UNITED STATES PATENT AND TRADEMARK OFFICE

APPLICATION NO.	FILING DATE	FIRST NAMED INVENTOR	ATTORNEY DOCKET NO.	CONFIRMATION NO.
09/880,616	06/12/2001	Nisha D. Talagala	5181-83701	5974

Office Action Summary

DETAILED ACTION

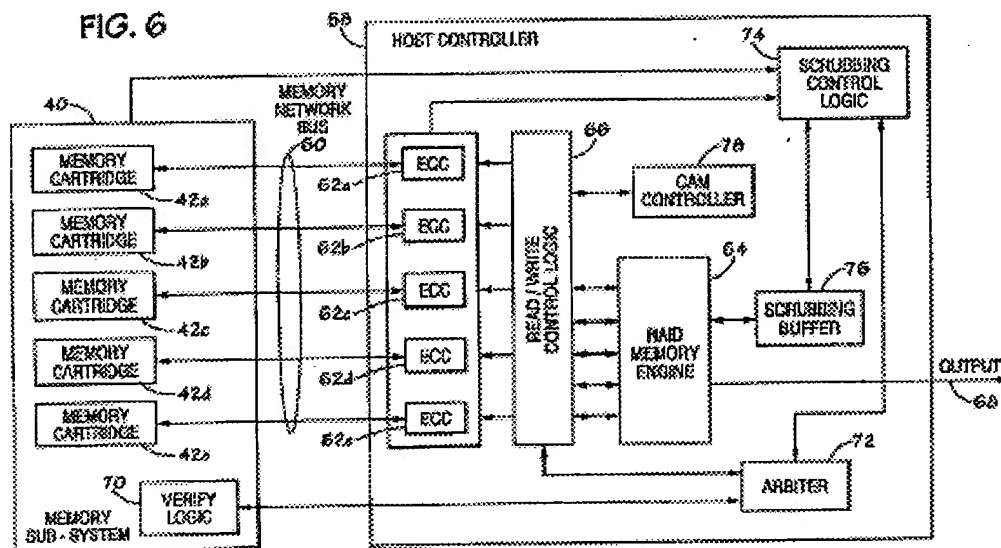
However **MacLaren et al.** discloses scrubbing means, e.g., in para. 54 et seq., "*The memory control devices 48a-e, the error detection and correction devices 62a-e and the RAID memory engine 64 can be used to correct the data before it is written to the output 68. However, at this point the data residing in the memory sub-system 40 may still be corrupted. To rectify this problem, the data in the memory sub-system 40 may be overwritten or "scrubbed."* **MacLaren et**

al. discloses equivalent extent scrubbing, e.g., in Fig. 6: *blocs* 74, 76 and para. 49, “It should be evident from the discussion above, that performing error detection and correction on data residing in the memory sub-system 40 by relying on READ operations sent from peripheral devices will only result in detection of errors on those devices from which data is read. By relying on the READ command from a peripheral device, certain areas of memory may sit idle for extended periods thereby allowing data errors to accumulate undetected. To address this issue, an additional piece of logic may reside in the memory sub-system 40. The verify logic 70 initiates a routine based on an operator instruction, a pre-determined periodic instruction, or some sequence of events such as a hot-plug event, for example. The verify logic 70 initiates a check of the specified memory location in the memory sub-system 40 without depending on normal READ accesses by external devices.”

FIG. 7

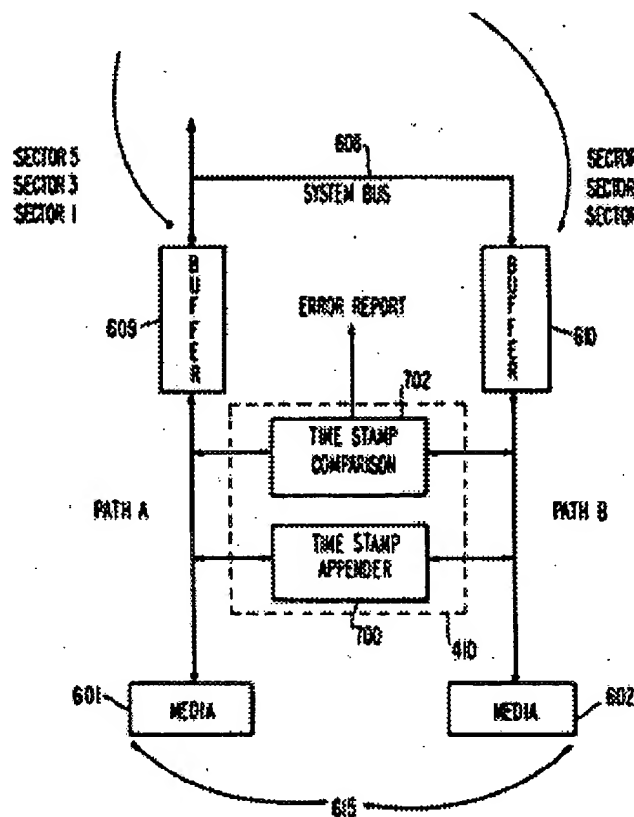
However silent error detection via parity/CRC/checksum means for RAID adequate operation is one of the desiderata of RAID design. For example, **Katz et al.**, in an analogous art, discloses RAID *architecture* in Figs. 6-7, and col. 1 line 7 – col. 18 line 16.

wherein plural fields are provided for data error checking via CRC, e.g., 3^d field for RAID 310 and 6th field for RAID 504 along with means for time-stamping for tracking RAID status, e.g., device 601. Such data error checking is effected and configured for local or system-wide operation based on stimuli from either the system/extent/array controller or the local/RAID/disk controller. Corrective steps are taken in col. 6 line 35 et seq., e.g., via RS code spread across plural disks for data reconstruction in col. 6 line 62 in a manner equivalent to the claimed invention, e.g., *“a Reed Solomon coding algorithm is used to calculate the check data that is stored on the check drives. In a particularly preferred embodiment this check data is distributed across several physical disk drives in a striped manner like that of the previously described RAID level 5 architecture. A stripe comprises corresponding sectors across a set of disk drives, some of which sectors contain mass storage data and others of which sectors contain check data for the mass storage data sectors within the stripe. A stripe may be one or more sectors deep. Such stripes on a set of disks are grouped into one or more of what is hereafter referred to as redundancy groups. In this arrangement the physical devices comprising the check drives for a particular stripe varies from stripe to stripe. The widths of the stripes (i.e., the number of physical storage devices spanned by each stripe) are equal within a redundancy group.”*
